## **TOWNSHIP OF LOWER MERION**

### **BUILDING & PLANNING COMMITTEE**

**WEDNESDAY, JULY 29, 2026  
6:50 PM (Approximately)**

ITEM: **APPROVAL OF CERTIFICATES OF APPROPRIATENESS**

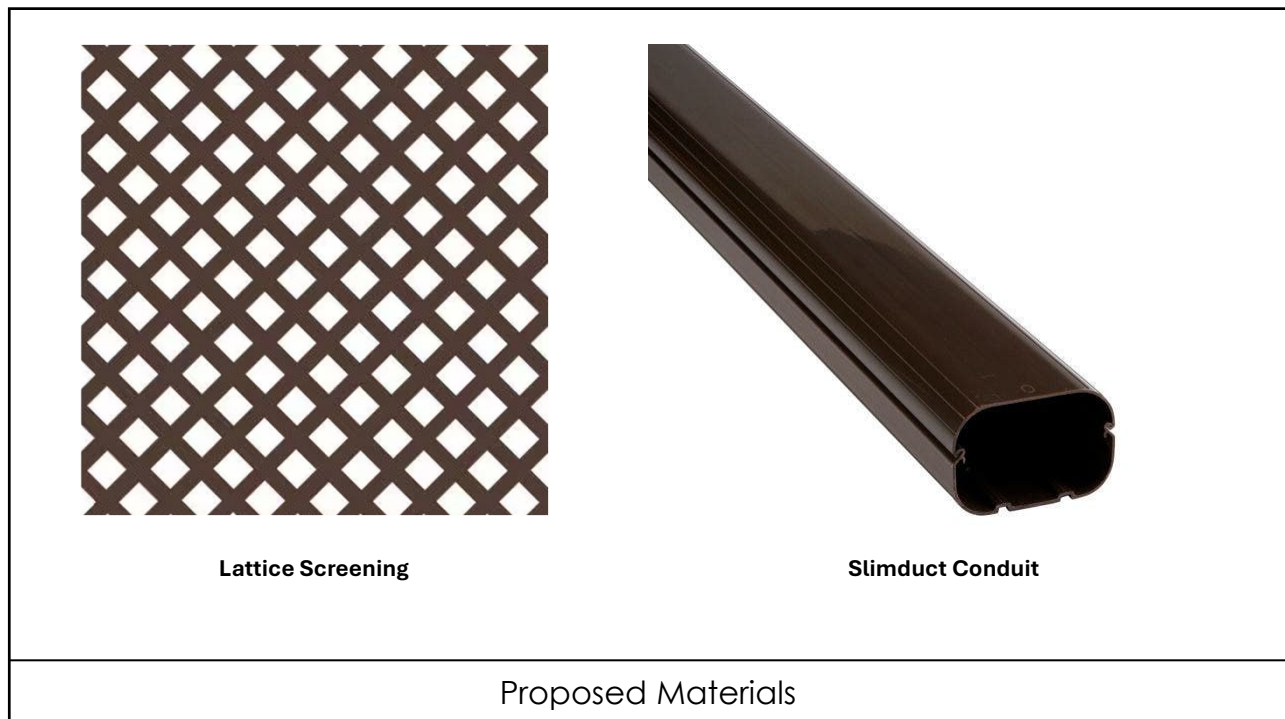
- The applicant proposes to remove one existing outdoor unit and install two new outdoor units. The two units are similar in size, with the greater of the two being 43"w x 58"h x 18"d. The newly proposed location (at the north side, rear of the building is the most appropriate location for these units. The unit to be replaced is significantly smaller than the new units. Where mechanical units must be placed adjacent to historic structures, especially when so visible from a public way like Merion Avenue, they should be screened with a component that obscures the units and is more appropriate to its historic environment. Vegetation is often a means of screening HVAC equipment, but there does not appear to be enough room for that. A fence is likely the best option to screen these new units, and if the applicant chooses to pursue this option, it should identify in the site plan where the fence will be constructed, its dimensions and its material.

- The newly submitted documents note that the required linesets are to be installed at the interior of the building and run to the rear. At some point the lines will need to exit the building, and the applicant should clarify where the lines will come through the façade and connect to the

ODUs. Any penetration of the historic building envelope should be carefully executed, limited in its size to just accommodate the line sets, and should be as close to its associated outdoor unit as possible. Further, to the greatest degree possible penetrations should be limited, perhaps grouped together at a single penetration, or be grouped together, so that all line work can travel verticals within the building and only exit the building right at the outdoor unit. The applicant should supplement its site plan diagram with a photo of the rear façade and notations indicating where any linesets will exit the building.

**Following the acceptable documentation of outdoor unit placement, appropriate screening method and location, and detail and location of all penetrations through the building wall and/or linesets proposed to be installed on the face of the walls, we would recommend approval of this application based on Standard 9.**

Window Pack-Out

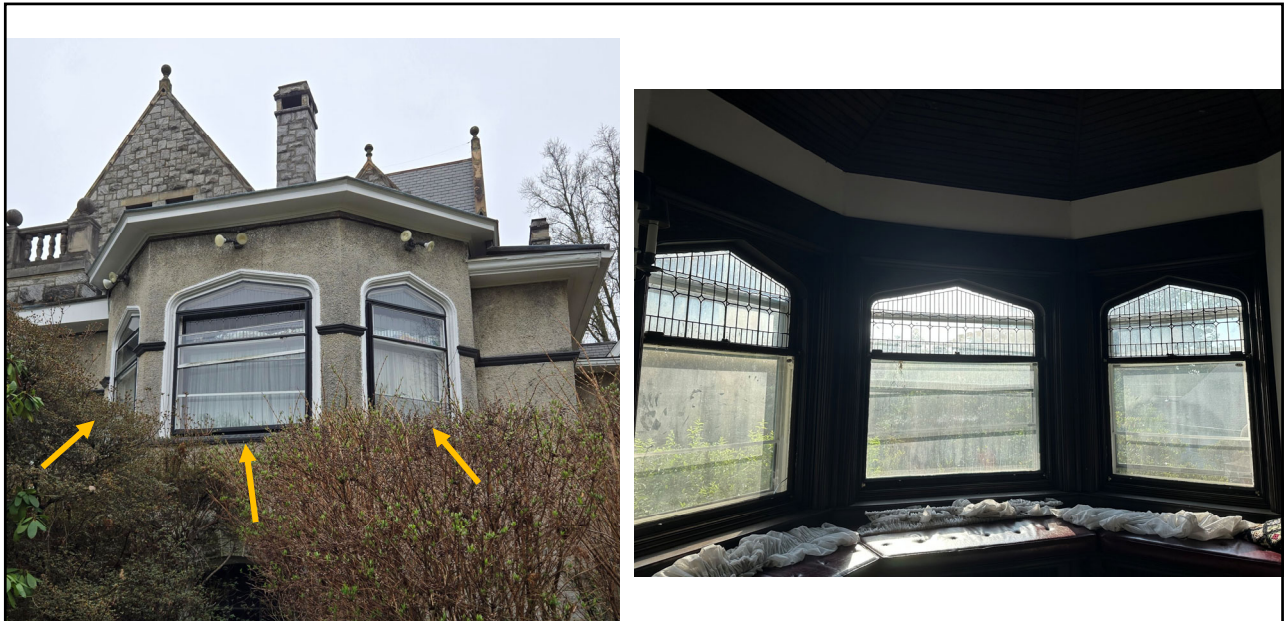
This is not considered an appropriate alteration according to the SOI Standards.

component below the overlapping meeting rail among other inappropriate details. Not only would the width of the frame assembly be increased and the daylight opening of the bottom sash be decreased at the left and right jamb, but the solid dimension at the former meeting rail location would increase from approximately 1.5" to as much as 4.5- 6", depending on where the new window is set. Further, the new window depth of 4" would need to be joined to the bottom of the upper sash which is approximately 1.5", creating another extremely awkward detail. This would create a drastic and inappropriate alteration to this window and would be in great contrast to all of the historic window forms.

Rendering – Garage and Landscaping Improvements

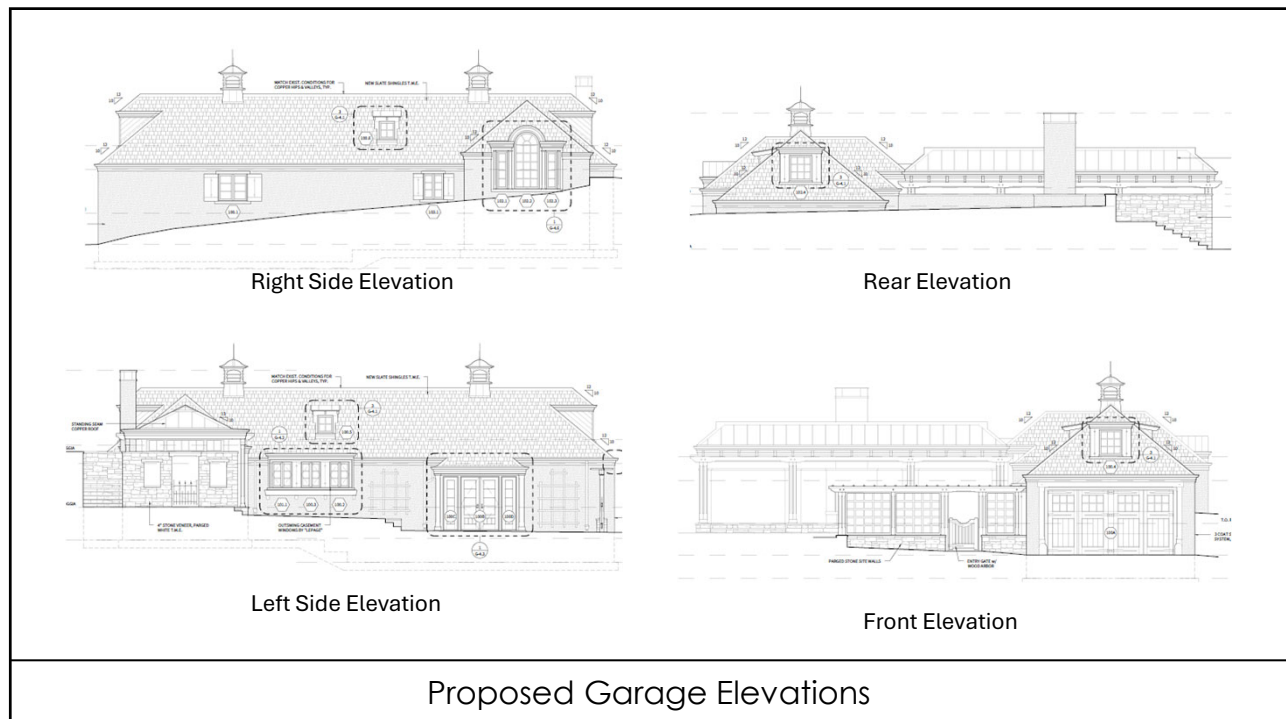
- The proposed rehabilitation and expansion of the garage will extend the garage towards the rear of the property approximately 40', allowing for the placement of 4 vehicles, 2 cars deep within the garage and an additional storage space beyond. The structure will remain one story, with a hipped roof to be finished with slate shingles to match the new slate shingles on the house. Copper gutters and flashing will also match the detail at the house. Walls will be stucco or whitewash/ parged stone, and doors and windows will be wood, again matching the LePage windows and doors specified at the residence. All specified materials are consistent with previous associated approvals and appropriate and complementary to the resource.

East Elevation – Existing and Proposed

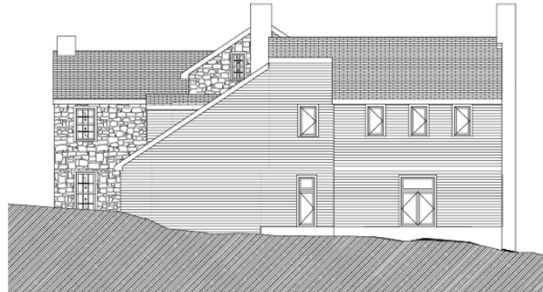
- The stone structure has been modified in the past to accommodate altered grades, resulting in an asymmetrical gable end. The applicant proposes to remove and replace the roof framing and adjust grades at the rear gable to return the end wall to its original form. In the re-framing of the roof, a new loft floor will be established, and rear shed dormers will be added to expand the available volume at that upper level. The form, dimension and detail of the proposed rear dormers are very appropriate to the volume and pick up on the proportions and details of its existing features. Doors and windows are proposed to be aluminum clad wood with simulated or authentic divided lights.
